# PRELIMINARY DRAINAGE REPORT

## CROSSROADS MIXED USE EL PASO COUNTY, COLORADO

NOVEMBER 2020

PCD Filing No.:  
SP-20-011

PROPOSED DRAINAGE MAP  
CROSSROADS MIXED USE  
JOB NO. 18-003  
DATE PREPARED: NOVEMBER 21, 2020  
DATE REVISED:

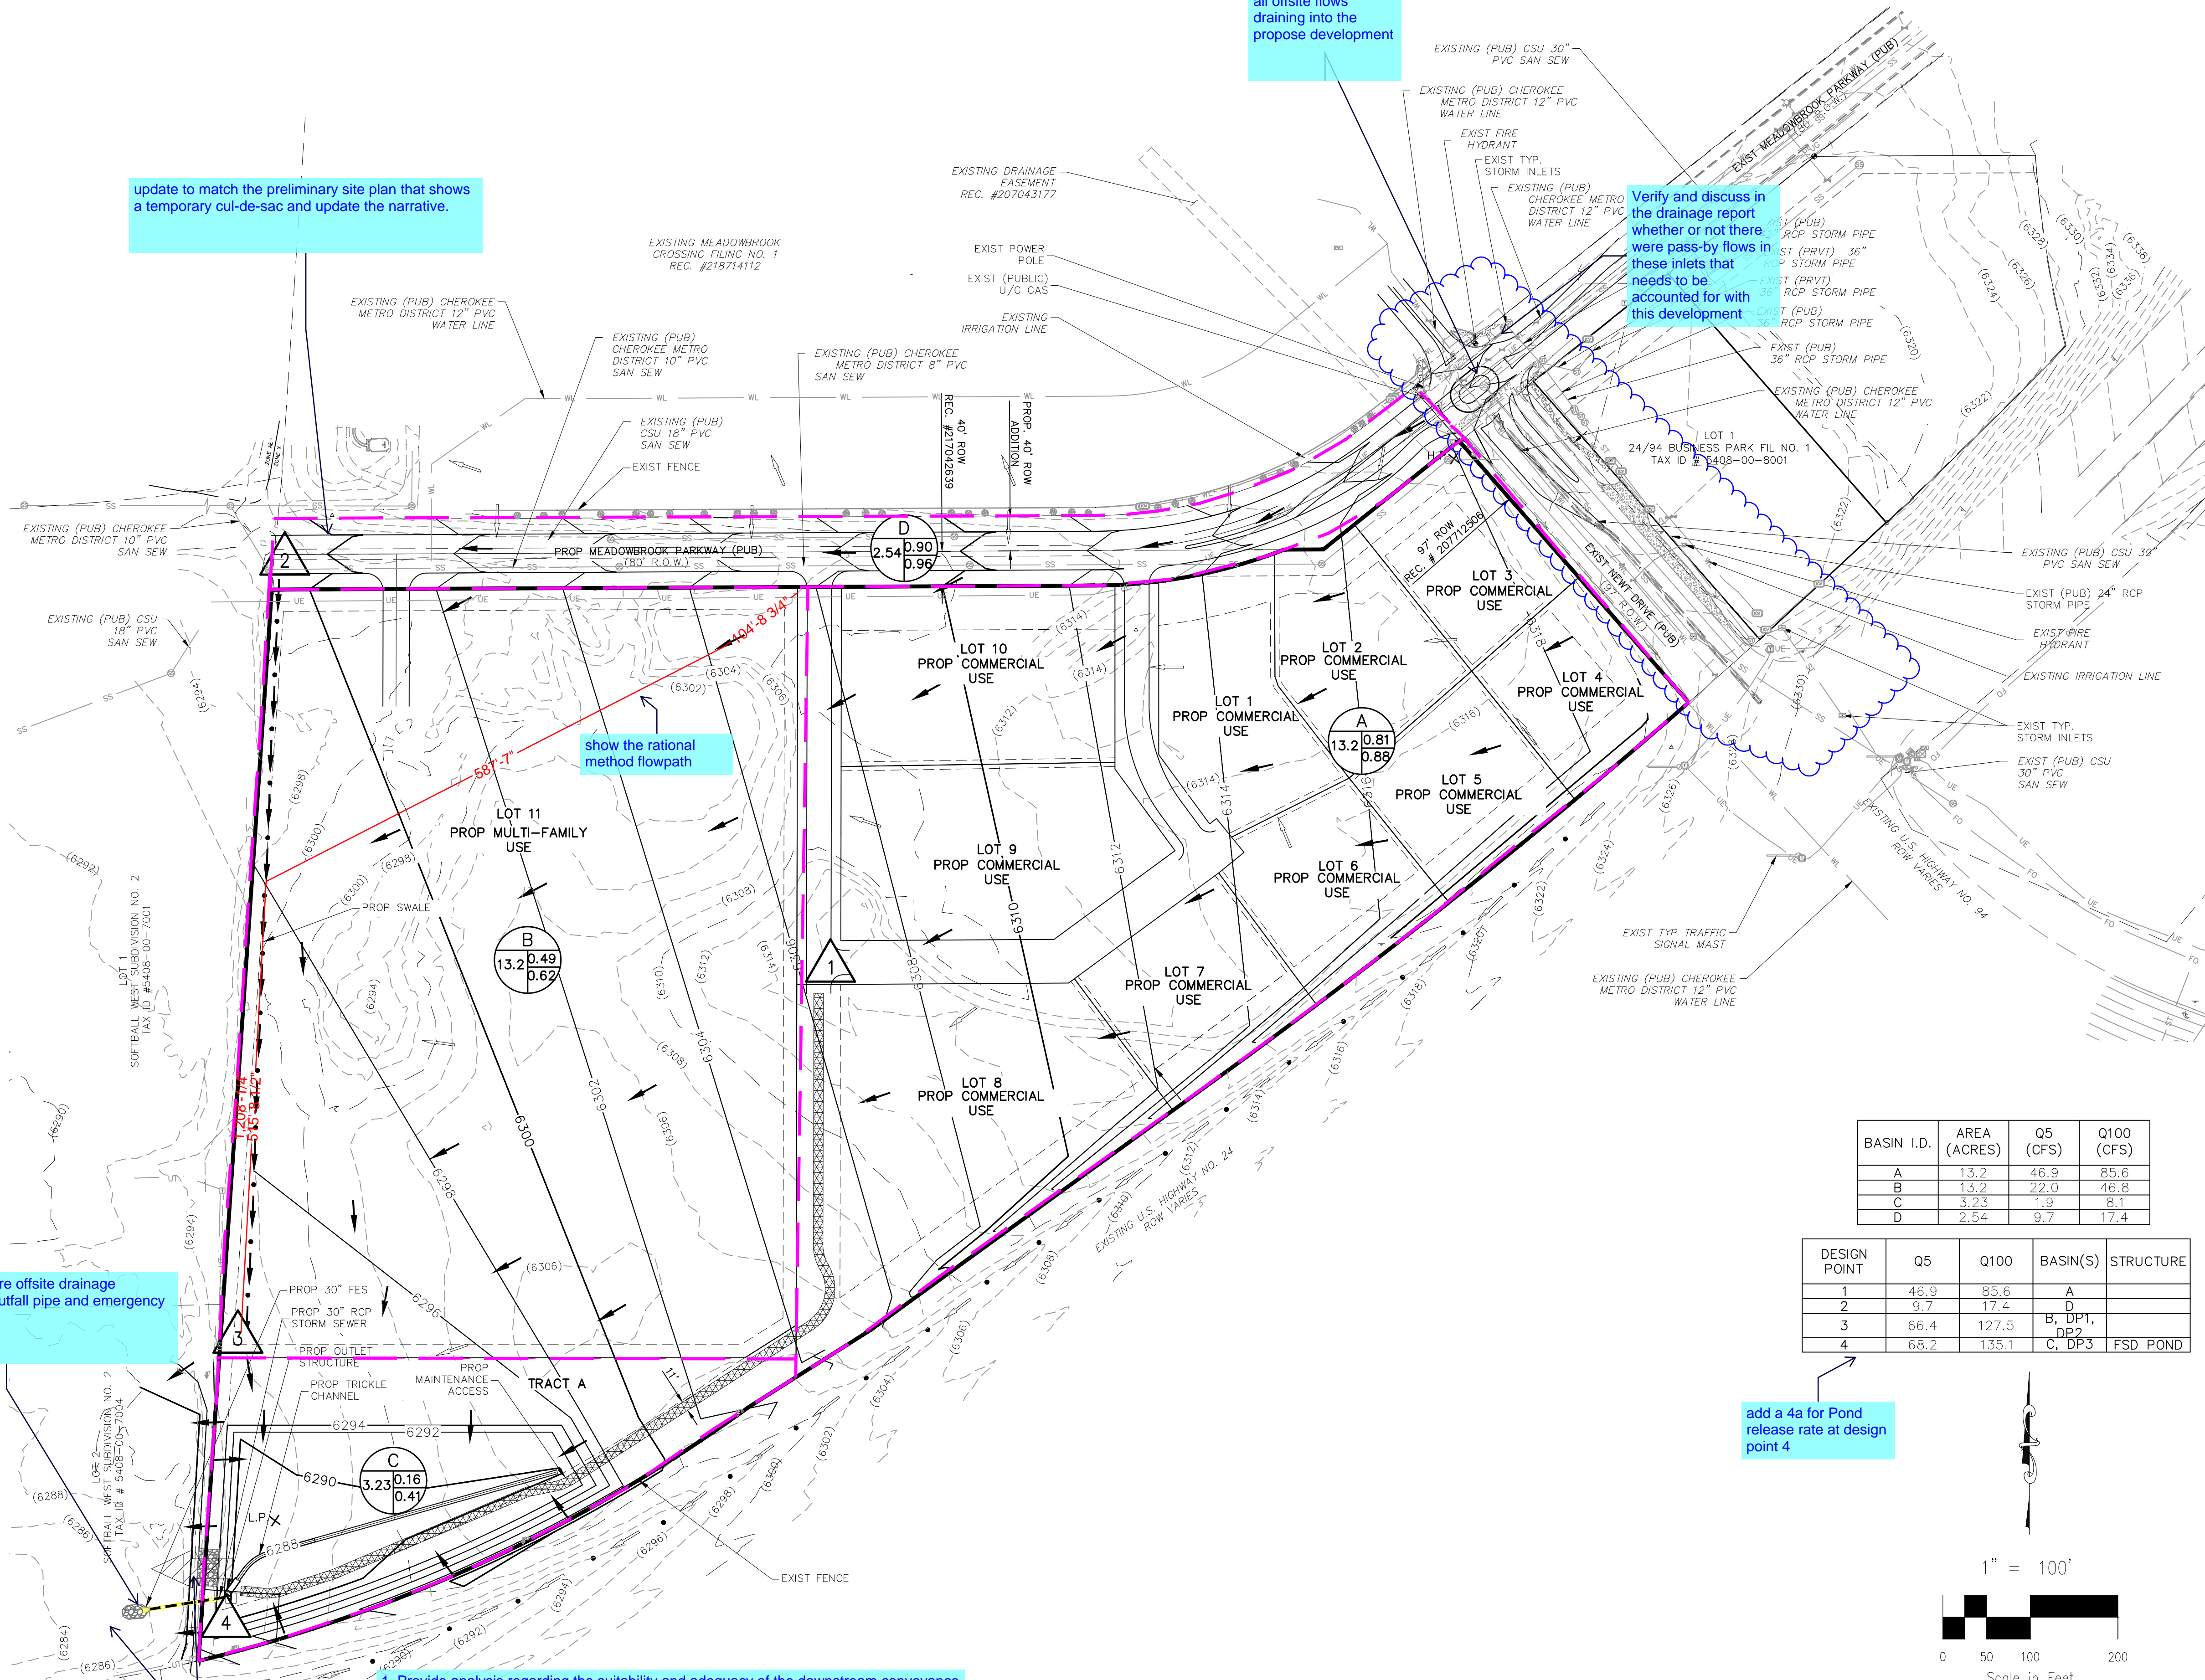
add a 4a for Pond release rate at design point 4

update to match the preliminary site plan that shows a temporary cul-de-sac and update the narrative.

Identify and include all offsite flows draining into the propose development

Verify and discuss in the drainage report whether or not there were pass-by flows in these inlets that needs to be accounted for with this development

show the rational method flowpath

1. Provide analysis regarding the suitability and adequacy of the downstream conveyance between the pond outfall and East Fork Sand Creek (to include the emergency overflow path). The developed condition is a change in the characteristics from sheet flow in the historic condition to concentrated flow.
2. Show the flowpath from the pond outfall to East Fork Sand Creek
